BS EXTERIOR - NORTH & SOUTH LEVELS 6 THRU 18 ALUMINUM FRAME BROKEN THERMAL

WINDOW NOTES	
6	DESCRIPTION
G1	SPANDREL GLAZING W/ 2-1/2" METAL FURRING. SEE 13/A2.25. WHERE INTERIOR PARTITION ABUTS SPANDREL FURRING, SEE 2/A2.26.
G2	SPANDREL GLAZING, NOT FURRED (SYSTEM NOT EXPOSED TO TENANT LIVING SPACE).
G3	METAL LOUVER GLAZED INTO WINDOW FRAME. SEE DETAIL 15/A2.26.
G4	INTERMEDIATE VERTICAL MULLIONS FOR THIS SYSTEM TO HAVE 4" DEEP FINISH CAP EXTERIOR SIDE.
G5	WINDOW SYSTEM TURNS AT EACH VERTICAL MULLION. DIMENSIONS SHOWN ARE APPROXIMATE. WINDOW WALL CONSULTANT TO DETERMINE DIMENSIONS NECESSARY FOR FABRICATION. THIS ELEVATION IS DRAWN UNFOLDED.

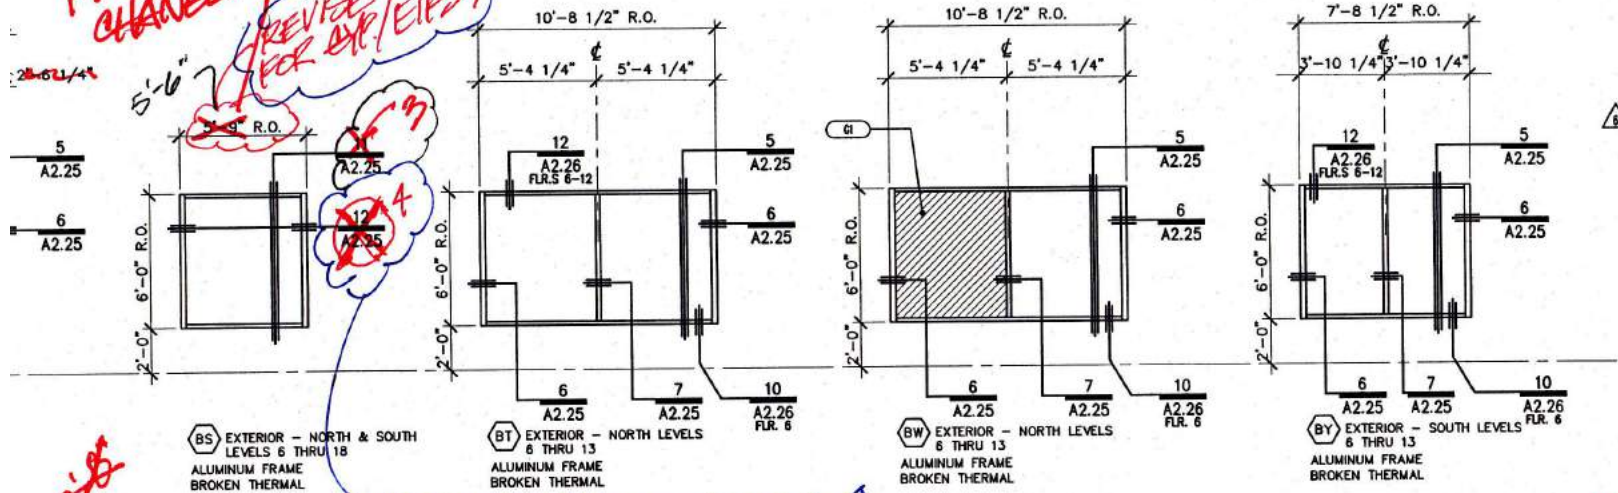
FP WAS CHANGED

NO PER CDC EMAIL 2-21-08

REVISE FOR EXP/EI/BS?

NO. 4

WAS NOT PICKED UP FOR 6

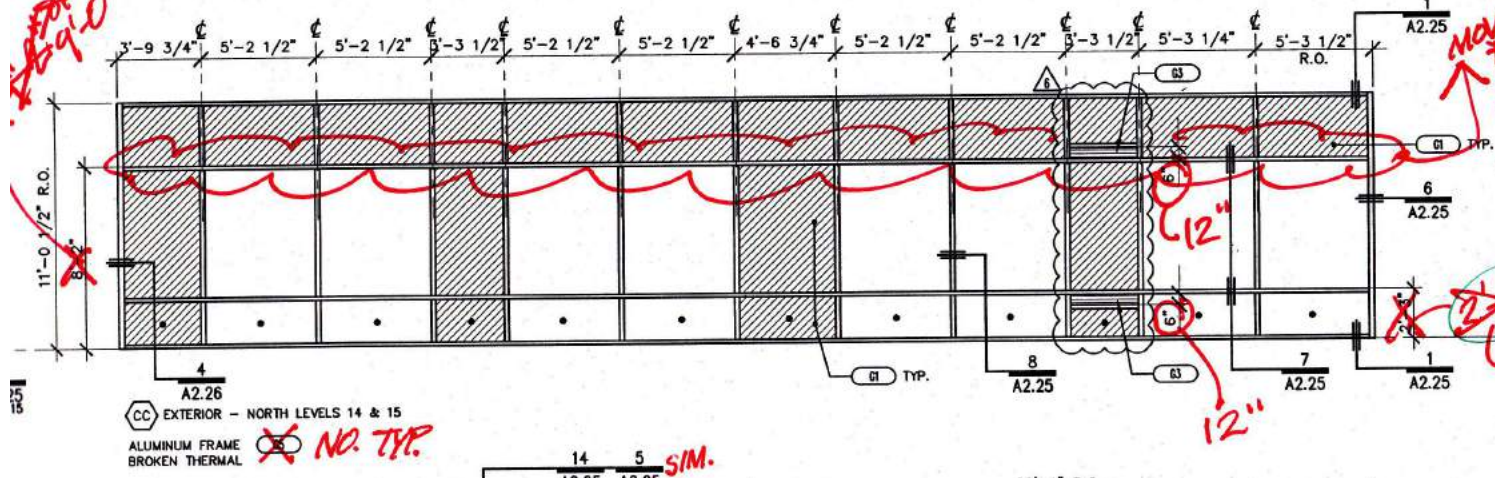
NOT IMPLEMENTED

MOVE TO 9' AFF
REDLINE STOPS TYP. ALL W.W.'S

REVISED BACK TO 2'-9" AFTER LOUVER COORD. MTR.

FOR KEEP @ 2'-3"

LOUVER

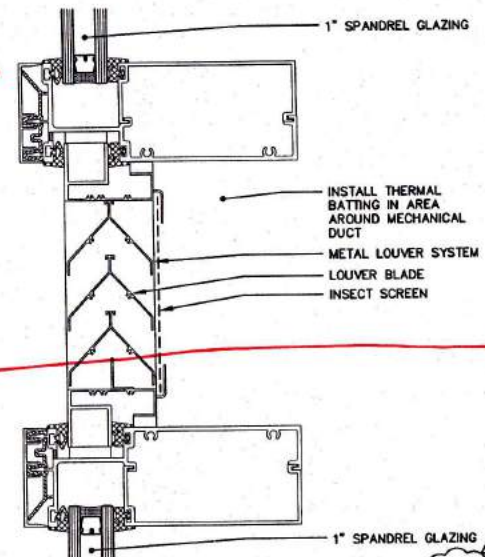
*BRAKE MTL.
IS RAPID CORROSION;
USE EXTRUDED ALUM.*
